Historic Resource Land Use Review – Approval Criteria, Findings, and Recommendations 9712 SE Cambridge Lane, Milwaukie, Oregon

Description of the Historic Resource Land Use Review Application

ADDITION FOR
 MARIE & GREG LATHROP
 9712 SE CAMBRIDGE LANE
 MILWAUKIE, OREGON 97222

Sheet Title:
 WEST
 ELEVATION

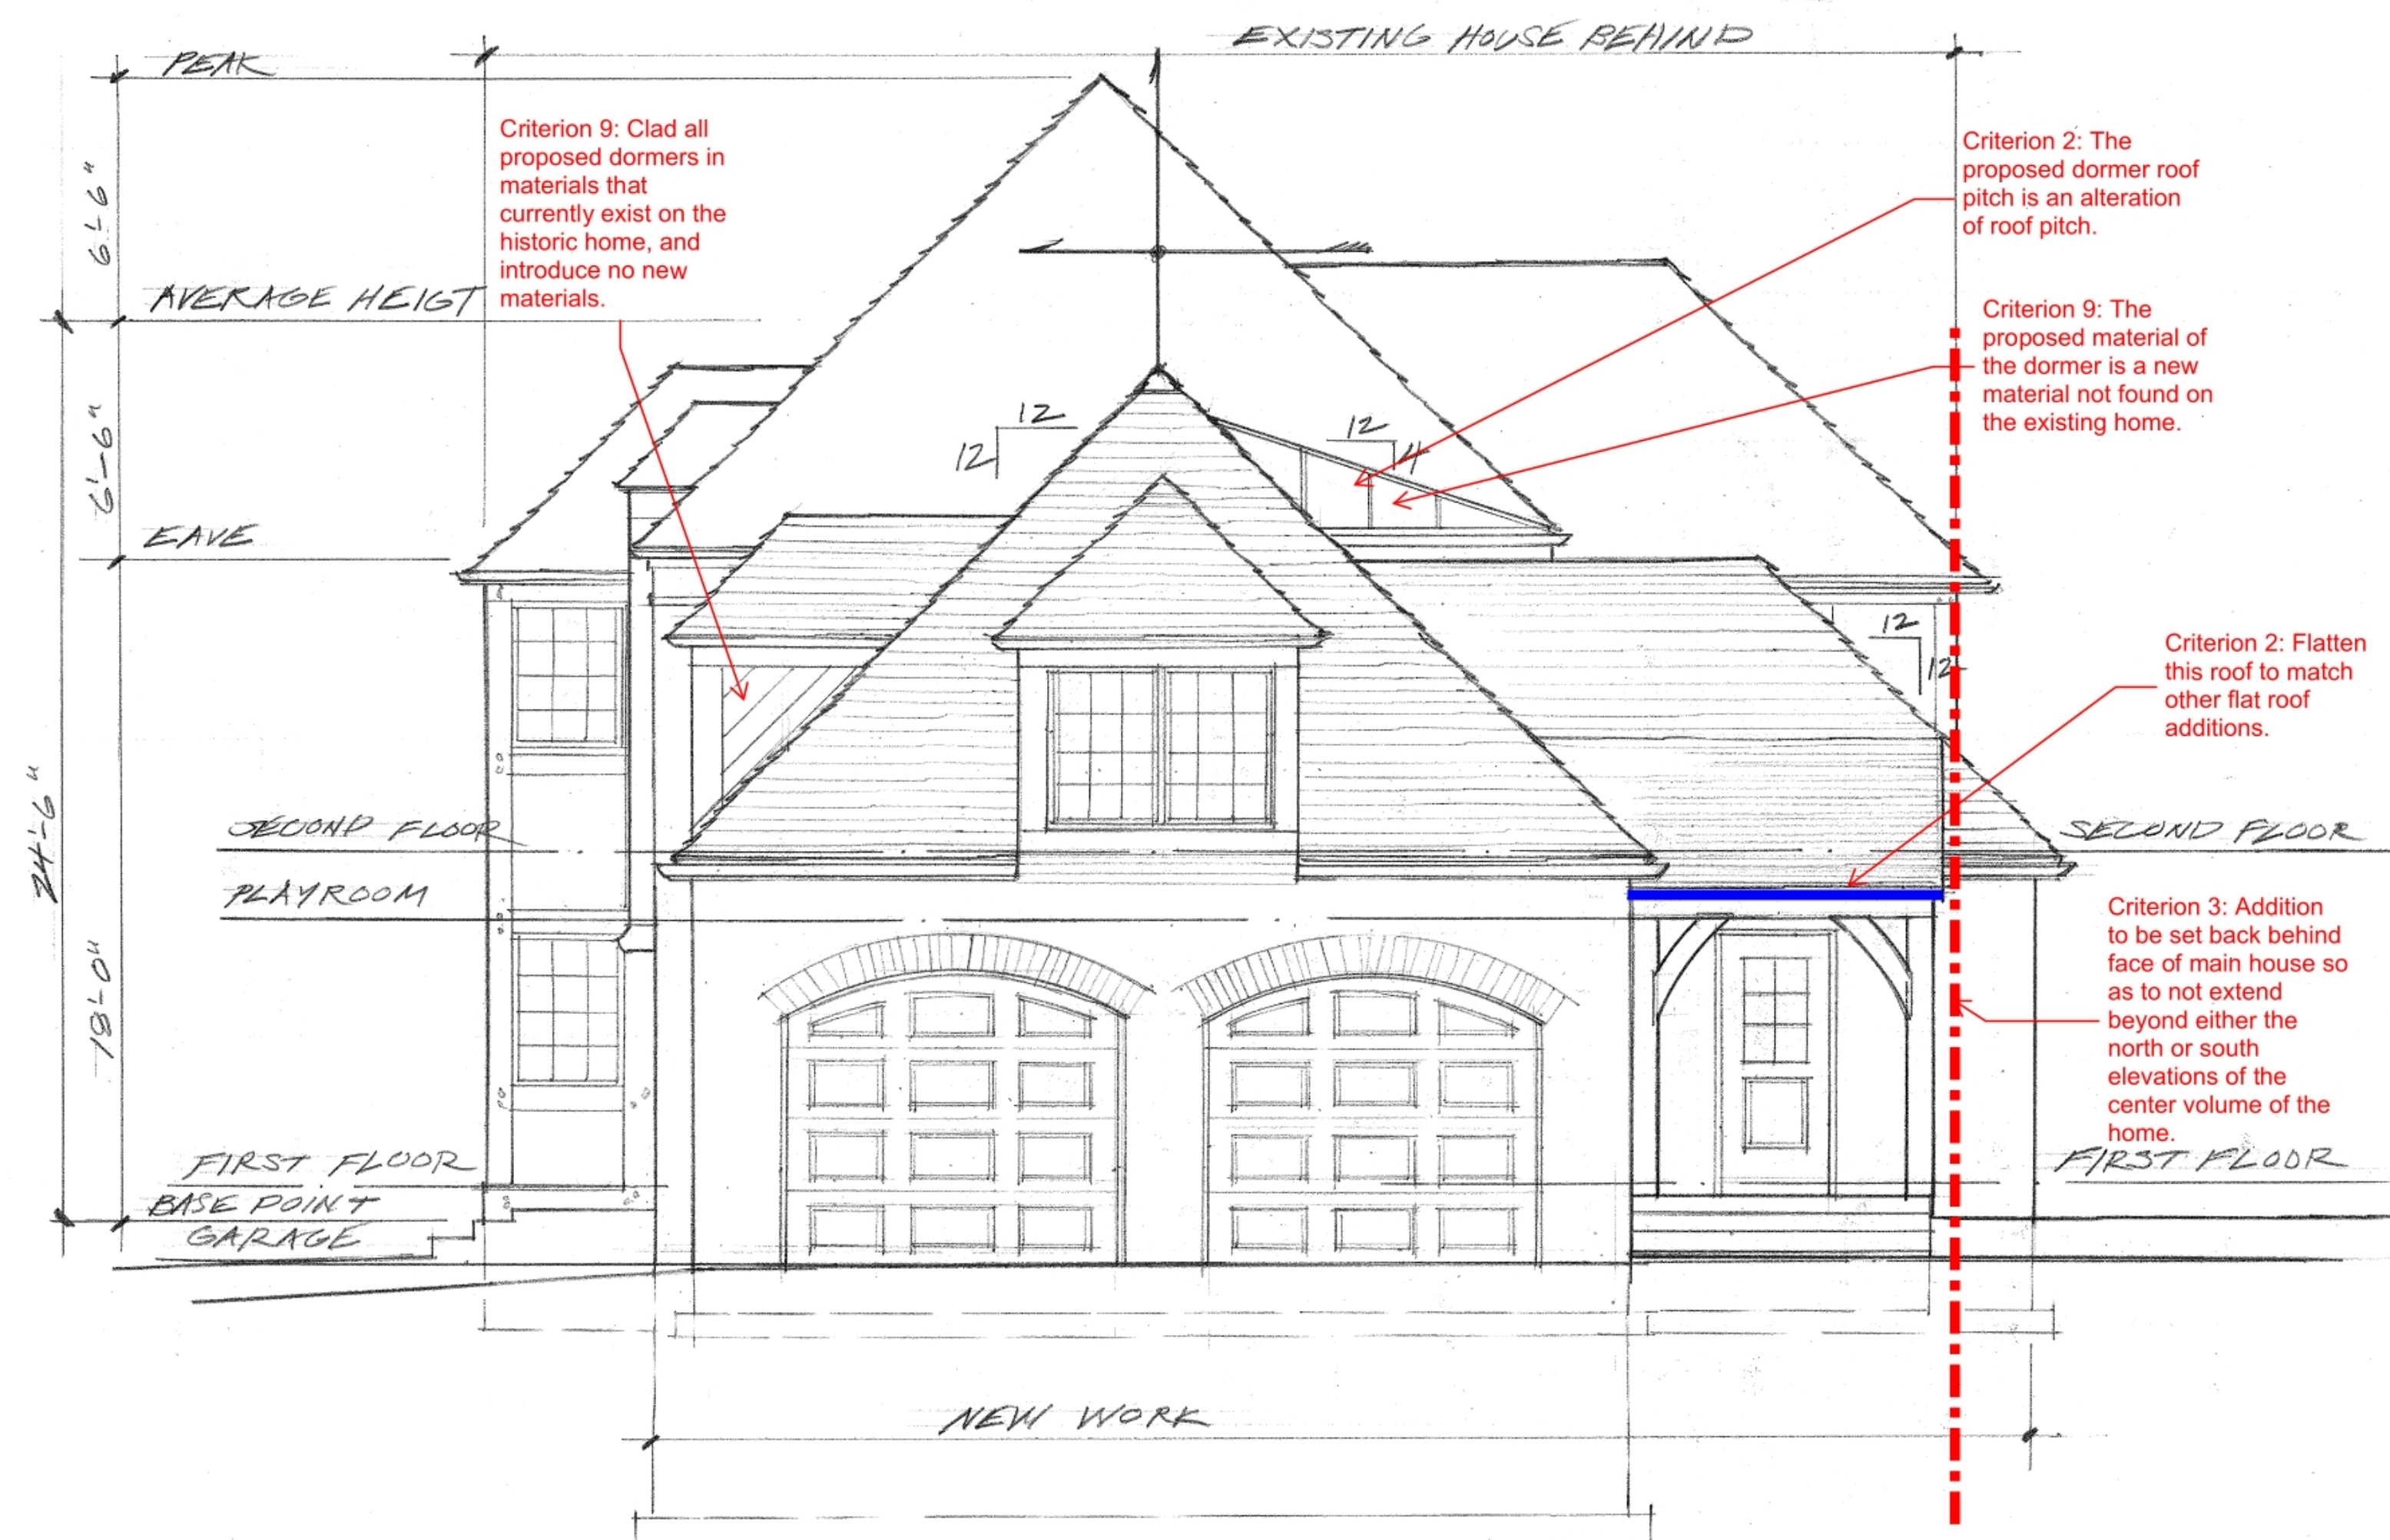
Criterion 9: Clad all proposed dormers in materials that currently exist on the historic home, and introduce no new materials.

Criterion 2: The proposed dormer roof pitch is an alteration of roof pitch.

Criterion 9: The proposed material of the dormer is a new material not found on the existing home.

Criterion 2: Flatten this roof to match other flat roof additions.

Criterion 3: Addition to be set back behind face of main house so as to not extend beyond either the north or south elevations of the center volume of the home.
